Access Compliance Report

Public Rights-of-Way

(Pedestrian Signals)

Intersection ID: N/A	Main Street:	Cross Street: N/A	Location: N/A
ADA ID: 94A79EF6CF5E	Signal Type: Two Push Buttons-APS	Overall Compliance: No	Severity Score: BTN 1:N/A BTN 2: N/A No BTN: N/A
Codes/Mitigation Info/Possible Solution		Field Measurements/Component Compliance

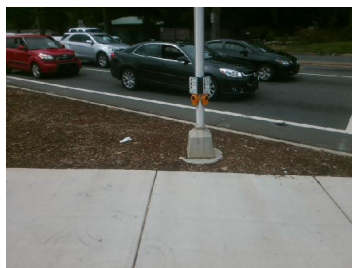
PROW/ADA: TMUTCD 4e.08, R404.7.3, , R404.2, R404.3

Yes	B 1 Clear Xing Direction?	ClearlyMarked	Yes	B 2 Clear Xing Direction?	ClearlyMarked
	B 1 Crossing Direction	To SW		B 2 Crossing Direction	To NW
Yes	B 1 DistanceTo XWalk (in)	0.0	Yes	B 2 DistanceTo XWalk (in)	36.0
No	B 1 DistanceTo Curb (in)	160.0	No	B 2 DistanceTo Curb (in)	117.0
Yes	B 1 Diameter (in)	2.0	Yes	B 2 Diameter (in)	2.0

Possible Solutions: Replace Signal Push Button With APS Button on New Post. Remove & Relocate Sign.
